General

This paper contains the German input for the SDC CG on Evacuations. It references a copy of the original guideline (MSC.1/circ.1238), which has been edited and restructured. In order to mark all changes, the following color coding was used:

Main Author: Tim Meyer-König (tmk@traffgo-ht.com), TraffGo HT, Germany.

Fig. 1: Duration distributions of an analysis with the significant run marked green.

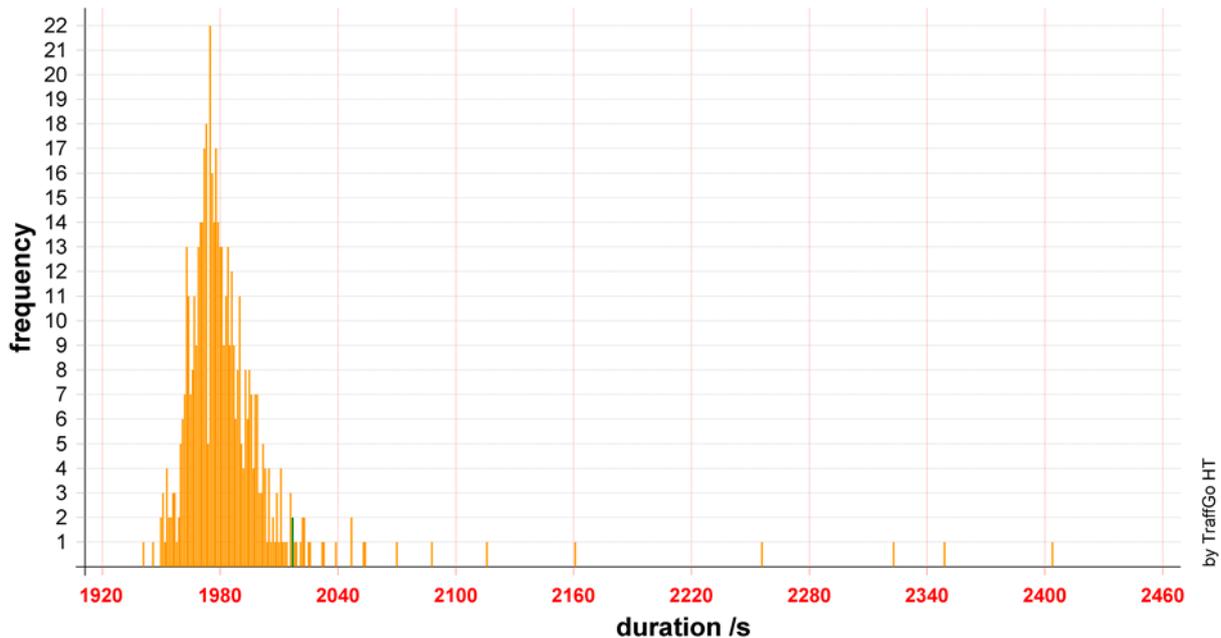
Based on FP56/6 and SDC2/14/2, two additional possible scenarios have been added to Annex 1, 4.2. They are not fully specified yet, this will follow, once an agreement has been reached on which scenarios to add. Since the variance of results grows by the number of different parameters, the number of calculations needed is increased to 500 (Annex 3, Appendix 1, 5.2) in order to allow for a reliable evaluation.

Fig. 1 shows, why a larger number of simulation runs is key to a reliable evaluation. The results shown have been gained through 500 simulations. If only 50 runs would have been analysed, it could not be guaranteed, that the few cases leading to very large durations would have been detected.
